Civil Aviation Authority

# EMERGENCY AIRWORTHINESS DIRECTIVE

Number: **G-2021-0010-E**

## ATA 28 – Fuel –Cylinder Quick Shut-off Valve Mounting Flange – Inspection / Replacement

Figure 1: *CB437 Flanged Adaptors for Quick Shut-Off (QSO) valves*

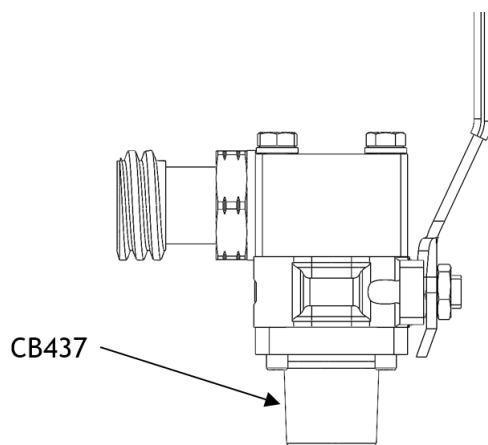
Certain Cameron Hot Air Balloon fuel cylinders are supplied with liquid offtakes that consist of a quarter turn ball valve mounted on a flanged adaptor (P/N CB437, see figure 1). Two recent batches of these adaptors have been manufactured with non-conforming (undersize) threads.

In certain cases, when the minimum sized adaptors are combined with cylinder bosses at maximum tolerance dimension and assembled to fuel cylinders, the thread can impinge (“bottom out”) on the cylinder boss. Although the required tightening torque value can be achieved at installation, the torque required to unscrew the flange could be below the minimum value. In extreme cases the adaptor may be unscrewed by hand.

4. From the effective date of this AD, do not install an affected part on any cylinder.
5. Within 4 months after the effective date of this AD, modify each cylinder by replacing the P/N CB437 issue F QSO flanged Adaptor, with a P/N CB437 issue G (or later issue) QSO flanged adaptor in accordance with the instructions of the SB, or by replacing the QSO valve assembly with a handwheel valve part No CB0824-0001 (this part has a Rego-type hose connection).
